## STATE OF NEW HAMPSHIRE DEPARTMENT OF TRANSPORTATION

MANCHESTER 44501

## ADDENDUM NO. 1

TRANSITION RAIL DETAIL

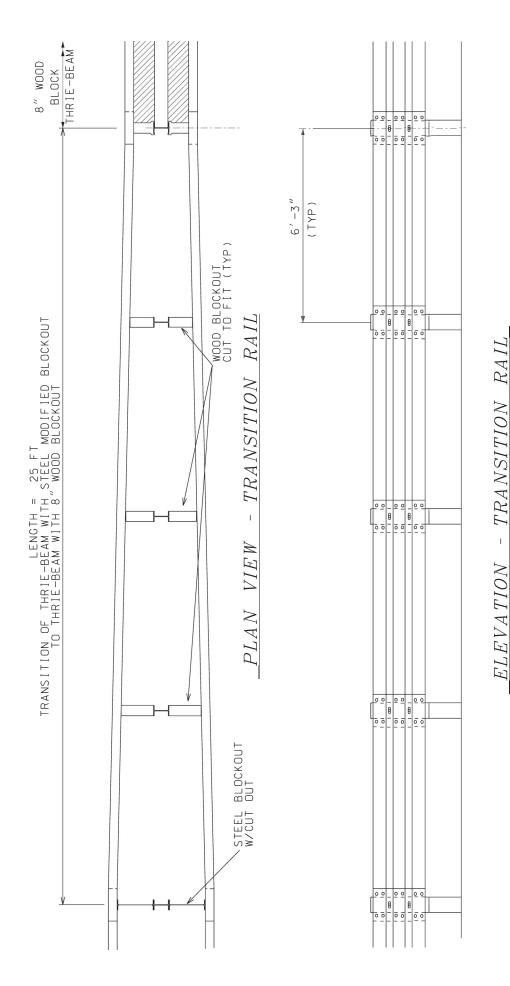
- 16. The transition section from thrie beam sections utilizing (steel) Modified Thrie Beam Blockout (PWB03) to 8" wood blockout thrie beam will be subsidiary to Item 606.21203 Double-Faced Beam Guardrail (Thrie Beam)(Steel Post). See *Transition Rail* detail for more information.

5. Replace, in the Proposal, page 16 (blank page) with page 16A, which is the Transition Rail detail.
